**Table B**  
**Agency Submissions Responses**

Figure 7: Predicted Flood Velocity Change Due to Project Rail Spur, 1% AEP Event

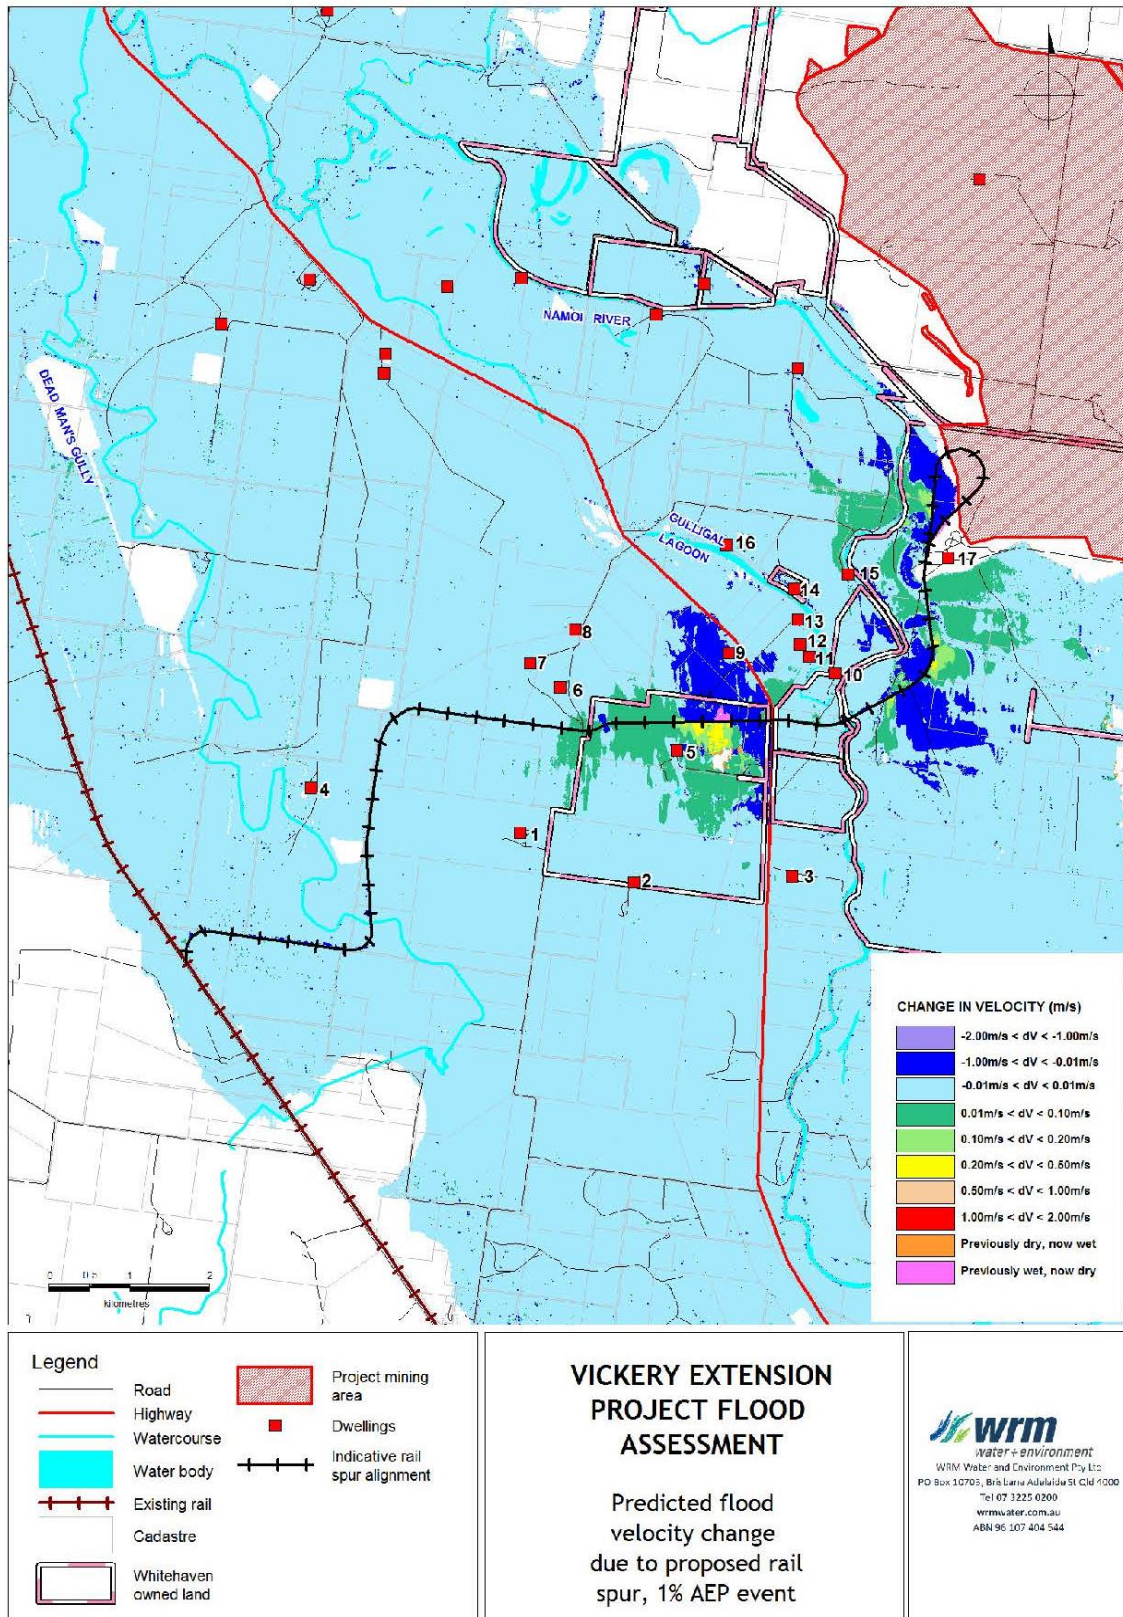
<b>2Q</b>	4. <i>An assessment of the impact of potential erosion should be considered for the areas where there is a measurable increase in flow velocity.</i>	<p>The flood model results predicted an increase in velocity between 0.2 m/s and 0.5 m/s at the ends of embankment sections of the Project rail spur (Figure 6.13 of Appendix C of the EIS, reproduced below as Figure 7). Note that Whitehaven proposes to elevate all section of the Project rail spur west of the Namoi River on piers and/or pylons.</p> <p>The predicted increases to flood velocities in localised areas would comply with the velocity impact requirement set out in the <i>Draft Floodplain Management Plan for the Upper Namoi Valley Floodplain 2016</i> (Draft FMP), and would be constrained to Whitehaven-owned land. Appropriate erosion and sediment control measures will be implemented at locations of increased velocity, where required.</p>

Figure 10: South Creek Riparian Zone Buffer Width

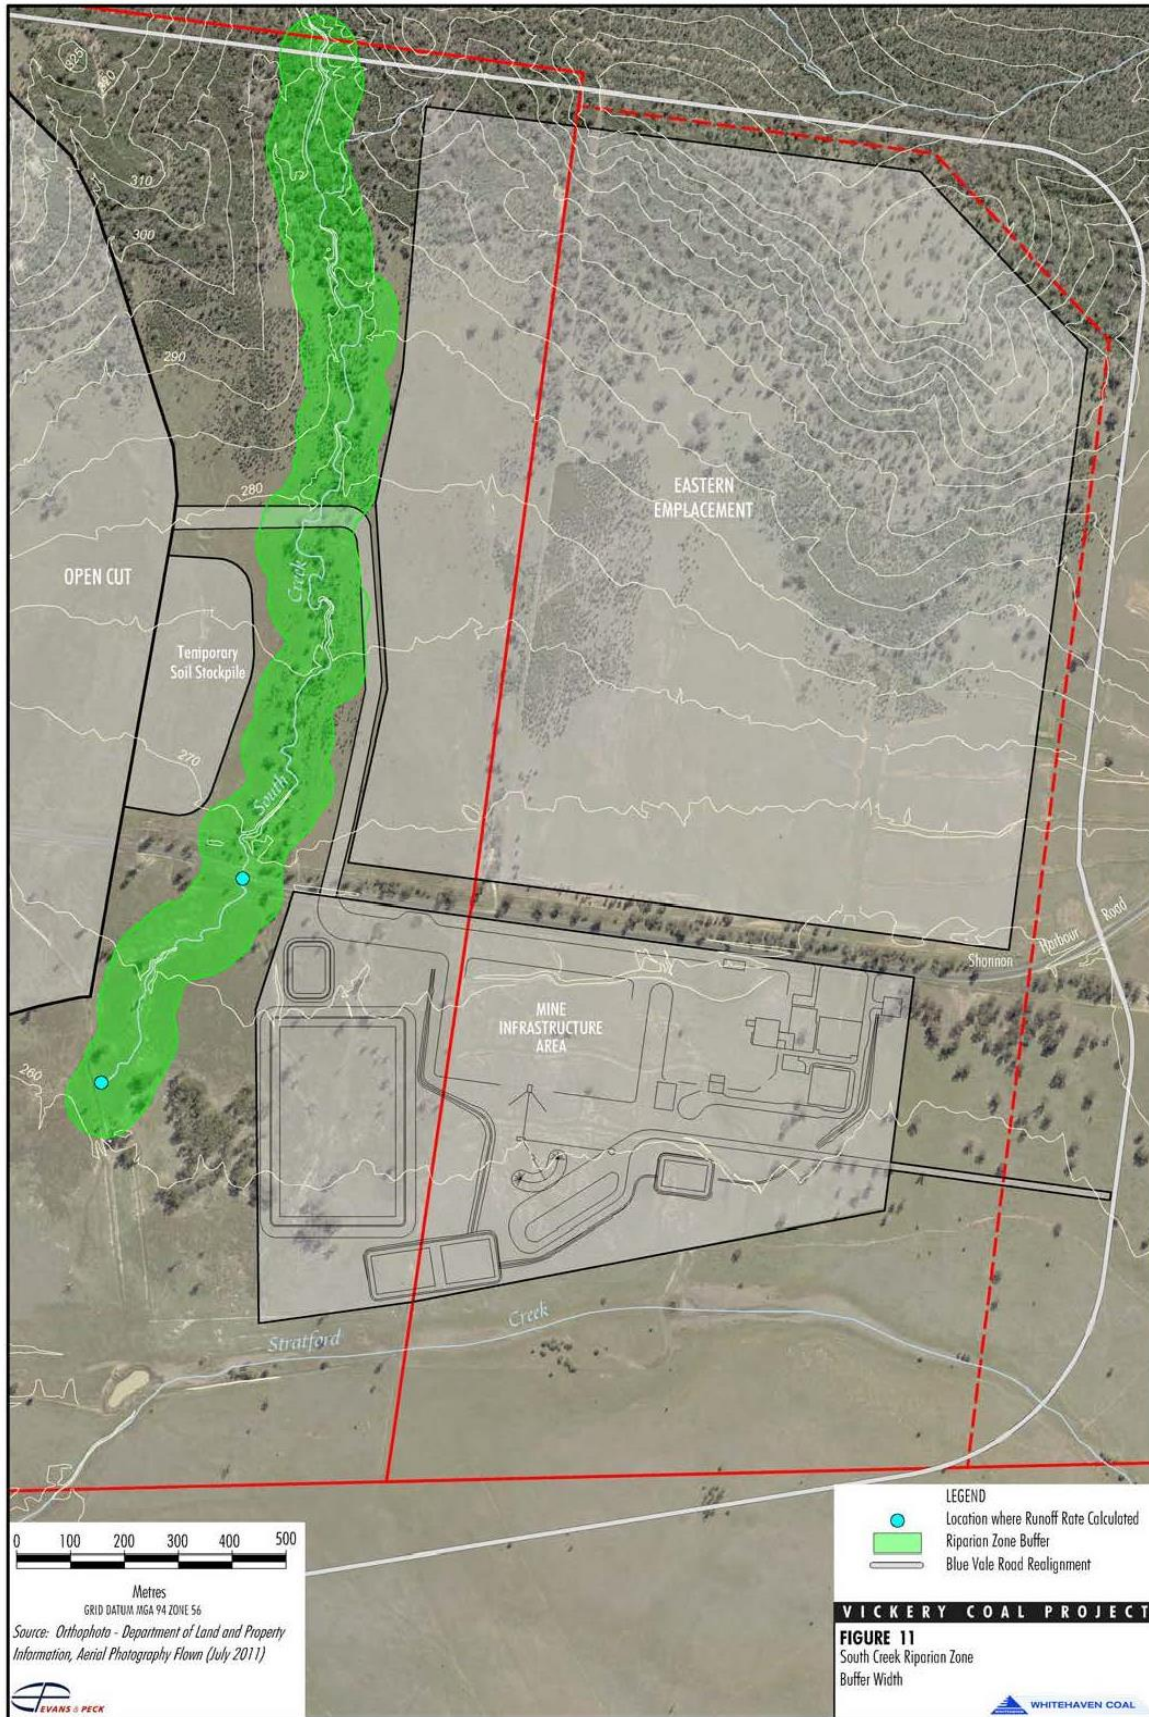
Recommendation	Response
<b>6D</b>	<i>An impact assessment should be provided of the proposed diversion of South Creek.</i>	There is no proposed diversion of South Creek for the Project (or for the Approved Mine). The secondary infrastructure area (previously the eastern emplacement for the Approved Mine) was designed to avoid South Creek, including a 40 m vegetation buffer to minimise impacts to flooding (see Figure 11 from the Approved Mine Surface Water Assessment, provided below as Figure 10).
<b>6E</b>	<i>The EIS should confirm the ability to achieve vegetated buffer requirements of 40m from the high bank to South Creek and Stratford Creek for all infrastructure proposed. This is not applicable for watercourse crossings.</i>	The secondary infrastructure area and flood protection bunds have been designed to maintain the 40 m vegetated buffer requirement along South Creek and Stratford Creek, consistent with the Approved Mine (see Figure 11 from the Approved Mine Surface Water Assessment, reproduced below as Figure 10).

**Figure 11: Bore Census**

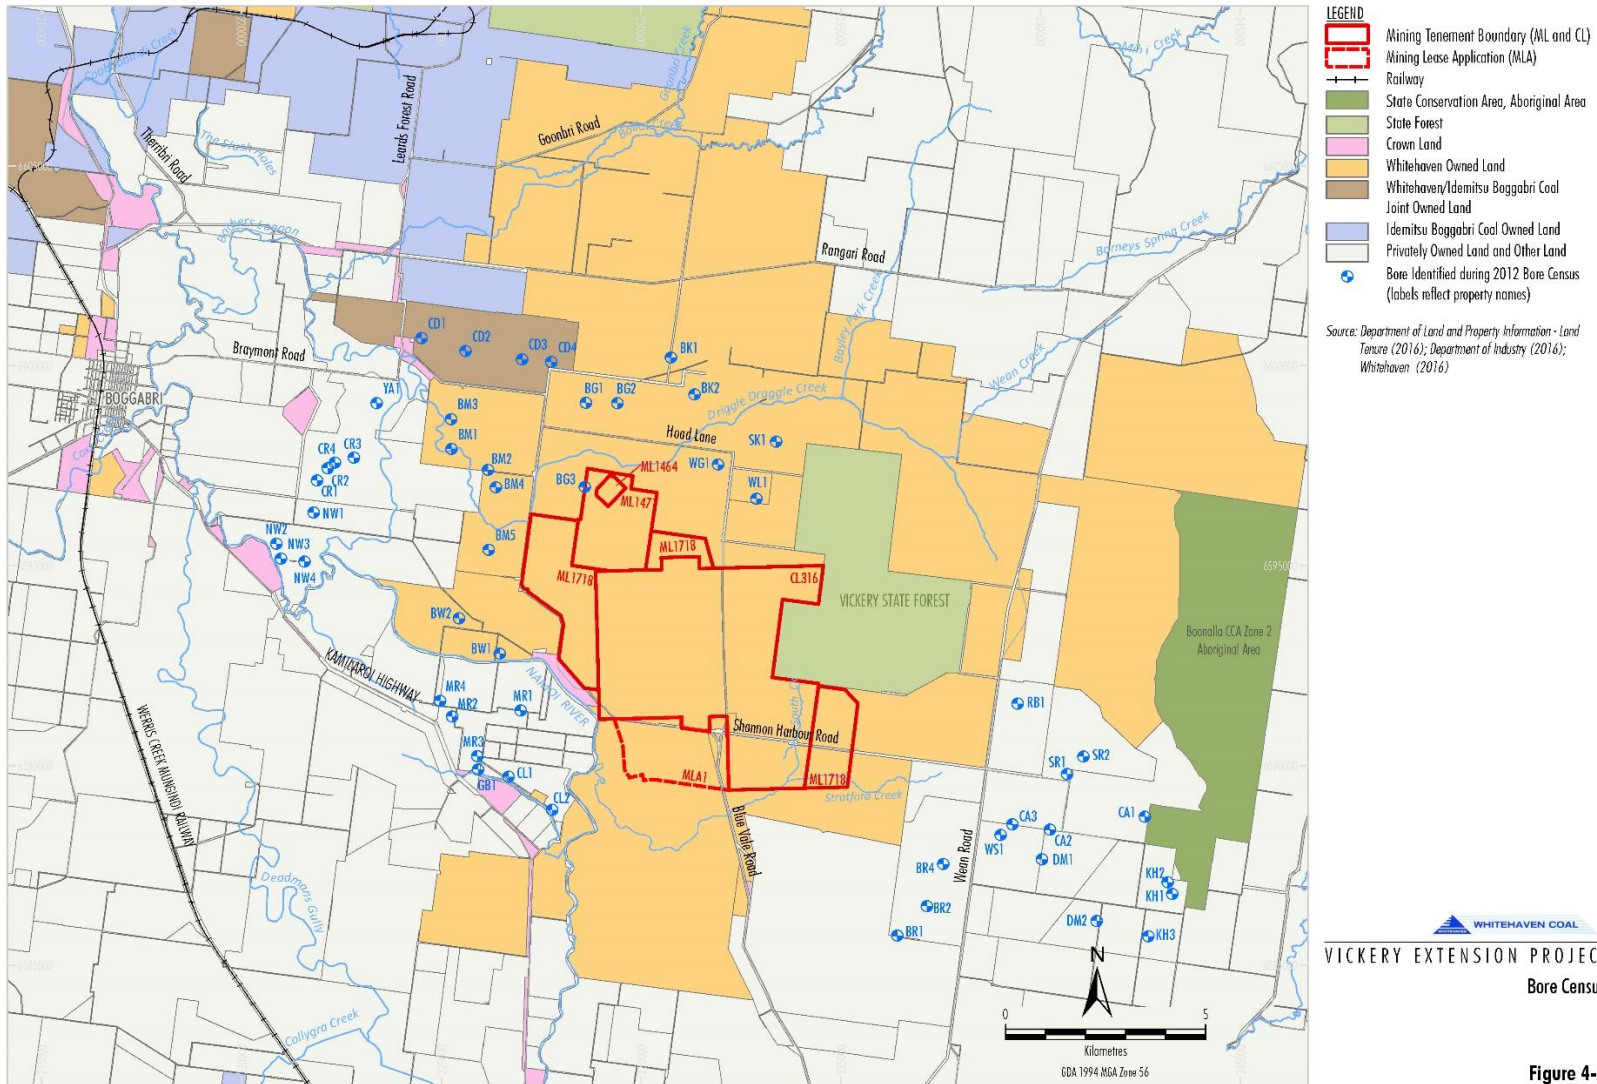
Recommendation	Response
7M	14. That the proponent model the impact on Boggabri's town bore (and future augmentation) depicted below and that Council have the opportunity to review the model and provide comment.	<p>The predicted cumulative drawdown at all privately-owned bores in the vicinity of the Project is less than 0.2 m, with the exception of 'RB1' (predicted drawdown of approximately 0.6 m) located to the south of the Rocglen Coal Mine (shown on Figure 4-8 of the EIS, reproduced as Figure 11 below).</p> <p>The incremental drawdown associated with the Project borefield only (compared to Project mining drawdown and other cumulative sources) is negligible at all privately-owned bores.</p> <p>The Boggabri town water supply bore location is shown on Figure 9. Based on the conservative predictions at privately-owned bores which are closer to the Project borefield (i.e. 'YA1', approximately 5 km from the Project borefield), predicted cumulative drawdown from the Project is expected to be less than 0.2 m at the Boggabri town water supply bore.</p> <p>On this basis, modelling of the potential groundwater drawdown at the Boggabri town bore is not considered to be necessary.</p>

Figure 13: Development Application Area

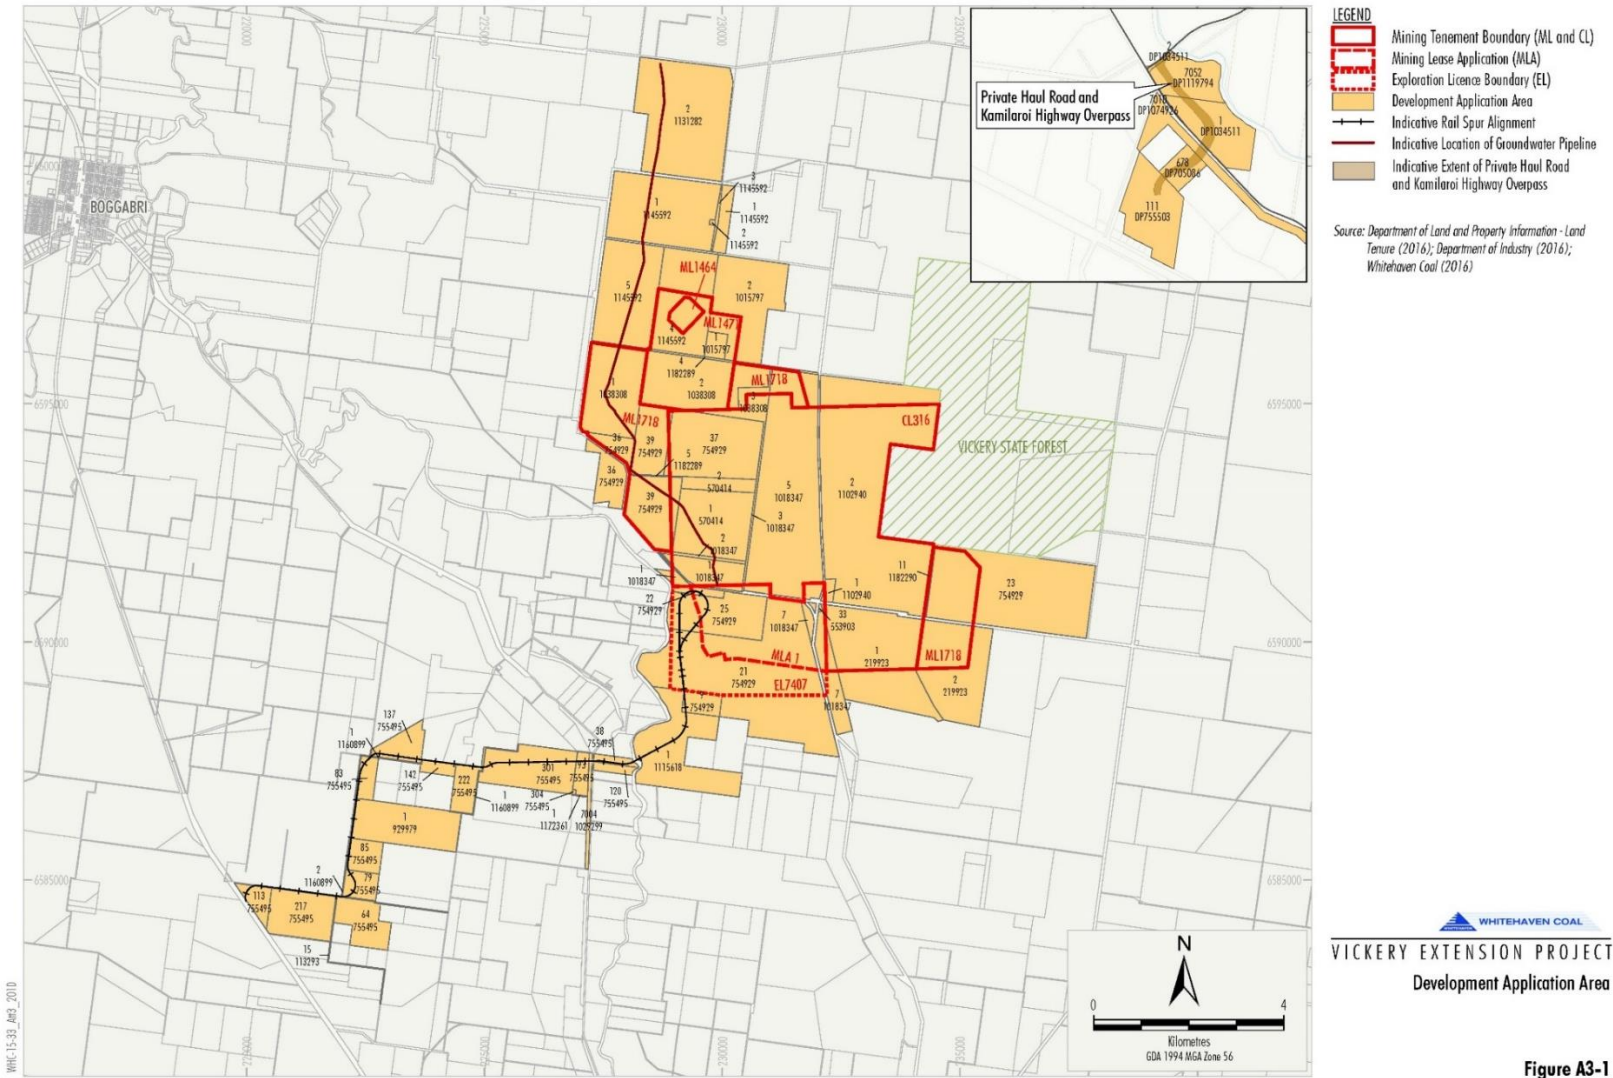
<b>8C</b>	<p>➤ <i>Extraction Limits: The development EIS indicated that extraction limits will be approximately 10 million tonnes per annum (Mtpa) and approximately 179 million tonnes over the life of the mine. Council believes that these extraction limits should be limited to 10 Mtpa and 179 million tonnes definitively, for the life of the development. Assessment of this application should be made on an exact figure to ensure that appropriate infrastructure and natural impacts are assessed in accordance with these maximums and that no further additional impact may occur.</i></p>	<p>This comment regarding conditions of approval of the Project is directed at DPE.</p>
<b>8D</b>	<p>➤ <i>Number of Voids: Clarify the number of final voids created. Page 3 of the Executive Summary, makes reference to reducing the number of voids from two (2) to one (1), however the table present on page 5 of the Executive Summary notes reduction from five (5) voids to two (2) voids.</i></p>	<p>The current landscape of the Project mining area contains five final voids remaining from past mining activities (i.e. Canyon, Red Hill, Blue Vale, Greenwood and Shannon Hill final voids).</p> <p>Two final voids were proposed for the Approved Mine, in addition to the existing Blue Vale final void. The Project final landform would include only one final void, in addition to the existing Blue Vale final void.</p>
